From: BRYAN Martin (EXTERNAL AREVA) [Martin.Bryan.ext@areva.com]
Sent: Tuesday, September 21, 2010 9:36 AM
To: Tesfaye, Getachew
Cc: KOWALSKI David (AREVA); Hearn, Peter
Subject: FW: DRAFT RESPONSES FOR FSAR Chapter 9 Weekly NRC Telecon
Attachments: Blank Bkgrd.gif; DRAFT RESPONSE RAI 351 Q.09.02.05-30 (d).pdf; DRAFT FSAR Changes RAI 351 Q.09.02.05-30 (d).pdf; DRAFT RESPONSE RAI 390 Q.09.02.02-106 (SAHRS).pdf; DRAFT FSAR Changes RAI 390 Q.09.02.02-106 (SAHRS).pdf

Request for Additional Information No. 351(4112, 4163), Revision 1

U. S. EPR Standard Design Certification

SRP Section: 09.02.05 - Ultimate Heat Sink

Figure 9.2.1-1—Essential Service Water System Piping & Instrumentation Diagram
Sheet 1 of 4

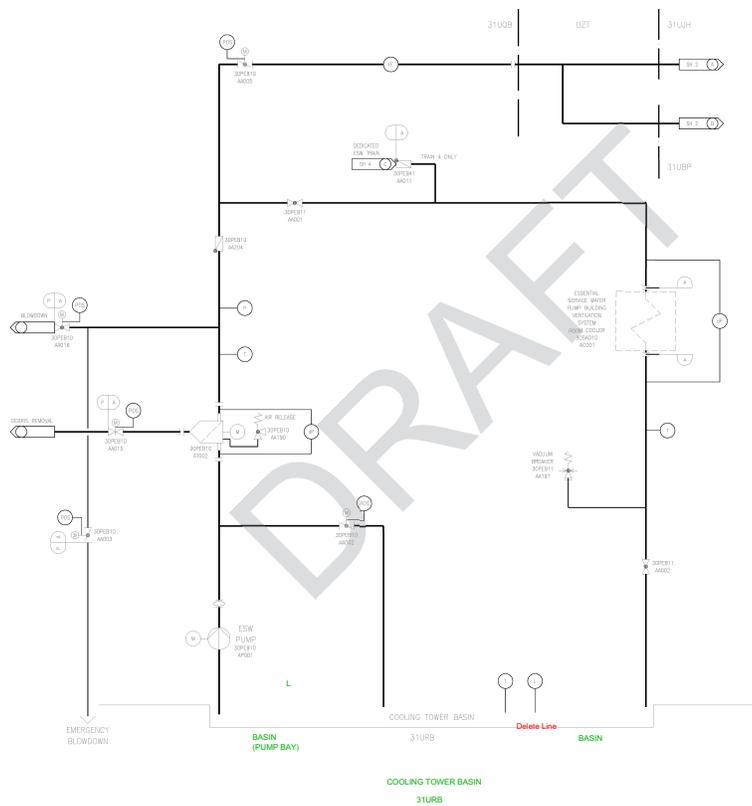
With regard to the response to Item (d), the staff does not agree that screens and filters that are solely for equipment protection are not safety significant. Filters and screens are relied upon to ensure that debris, aquatic organisms, and other material that find their way into the cooling tower basins do not adversely impact the capability of the essential service water system and ultimate heat sink to perform their safety functions. Without the screens and filters, pumps and valves can be damaged and rendered inoperable, heat exchanger tubes and cooling tower spray nozzles can become clogged, and heat transfer surfaces can become fouled. Therefore, ITAAC are needed to confirm the installation and proper mesh size of the filters and screens that are relied upon. Additionally, FSAR Tier 2 Sections 9.2.1 and 9.2.5 need to be revised to describe important filter and screen design specifications such as maximum allowed differential pressure and mesh size, including the bases for these specifications.

As stated in the response to RAI 175 question 9.2.5-10, the ESWS pumps are protected by screens located in the pump suction flow path. More specifically, the ESW cooling tower basin water flows to the pump intake structure through a coarse screen and a fine screen (located in series) prior to reaching the ESW pump. Both of these screens are safety related and extend across the full width of the pump bay opening and above the maximum water level to assure full control of the debris across the flow cross section.

The coarse and fine screens mesh sizes are primarily selected to protect the ESW pump operation, since the components downstream of the pump, such as the system user heat exchangers and UHS cooling tower spray nozzles, are protected by the in-line automatic backwash strainer referred to below. The coarse screen mesh is sized to prevent large debris from entering the pump intake structure and the fine screen mesh is sized to allow the debris with sizes acceptable for pump operation to pass the screen. The selected mesh openings of coarse and fine screens are 2 inches and 0.5 inch, respectively. Pump requirements based on mesh sizes will be in the specification and selection for the ESW, and ESW dedicated pumps. Both screens will be designed to include provisions for manual cleaning. Tier 1 Table 2.7.11-3 will be revised to include an ITAAC that confirms the installation and proper mesh size of the screens. Tier 2 Table 3.2.2-1 will be revised to include the debris screens.

Safety related water level indicators are installed in the UHS cooling tower basin, on the upstream side of the coarse screen, and on the downstream side of the fine screen to monitor the differential water levels across the coarse screen and the fine screen continuously through the Distributed Control System (DCS). Based on a pre-set magnitude of differential pressure between these water level indicators, operators will be alerted to inspect the screens for potential debris accumulation and cleaning. Due to the large flow area across the screens the pressure drop across these screens will be small. The maximum allowable total pressure drop across both the coarse and the fine screen is 12 inches. However, the operating procedures will include provisions for a low water level alarm responding to a differential pressure set point for the operator to initiate inspection and manual cleaning of the screens as necessary. The set pressure drop across the screens corresponds to a screen blockage that is well within the design limit of 12 inches and has no effect on the NPSH available or submergence for the pump. Such high blockage of fine screens is unlikely due to the makeup water supply to basin being free from debris and insignificant debris generated by cooling tower operation such as small concrete/ceramic particles and wear products and/or air blown debris entering the tower basin through air inlets. Tier 2 Figure 9.2.1-1 will be revised to include a level instrument in the pump bay.

Each safety related division also includes a cooling tower basin intake structure with removable coarse and fine screens. The screens protect the ESWS pumps and the dedicated ESWS pump against debris.

Figure 2.3.3-1—Severe Accident Heat Removal System Functional Arrangement

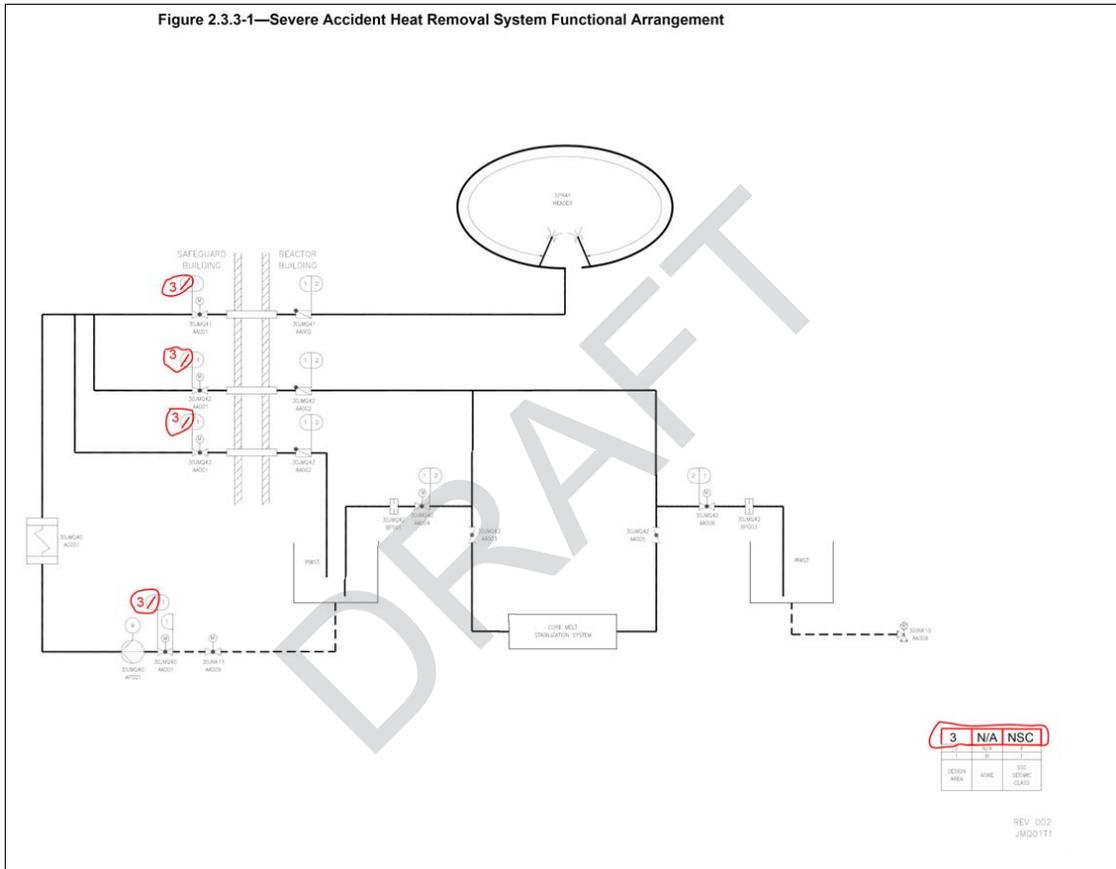
The staff noted that SAHRS is described in FSAR Tier 1, Section 2.3.3, "Severe Accident Heat Removal System;" however, it is not described in detail in Tier 2. The information in Section 19.2.3.3.3.2, "Severe Accident Heat Removal System," does not include the design information to support Tier 1. The support systems for SAHRS (dedicated component cooling and dedicated essential cooling) are described in detail in Sections 9.2. Since SAHRS is described in Tier 1, and the design descriptions, interface requirements, and site parameters are derived from Tier 2 information, the applicant should provide this information in Tier 2. In addition, Tier 1 FSAR Section 1.0, "Introduction," states that the "information in the Tier 1 portion of the FSAR is extracted from the detailed information contained in Tier 2".

As related to GDC 2, SAHRS component seismic classifications are provided in FSAR Tier 1 Table 2.3.3-1, FSAR Tier 1 Figure 2.3.3-1, and FSAR Tier 2 Table 3.2.2-1. Inconsistencies exist between these tables. Markups of FSAR Tier 1 Figure 2.3.3-1 and FSAR Tier 2, Table 3.2.2-1 are included in this RAI response to show necessary FSAR changes. Future FSAR Tier 2 Figure 19.2-22 is also included as Attachment 1 to show the simplified Piping and Instrumentation Diagram (P&ID) for SAHRS.

A Figure similar to FSAR Tier 1 Figure 2.3.3-1 does not exist in FSAR Tier 2. Currently, a general illustration is provided in FSAR Tier 2 Figure 19.2.2. A more detailed SAHRS Functional Arrangement drawing will be included in FSAR Tier 2, Chapter 19, as Figure 19.2.22. The Figure addition is shown in Attachment 1 of this response.

While more unique to Mechanical Design Features, it is noted here that inconsistencies with regards to Quality Groups and Seismic Classifications are also being corrected based on the review of Sections performed. For these items, corrective actions were initiated. FSAR Change Form 10-188 was initiated to address needed FSAR changes. The markups from this FSAR Change Form are attached (Attachments 2 and 3).
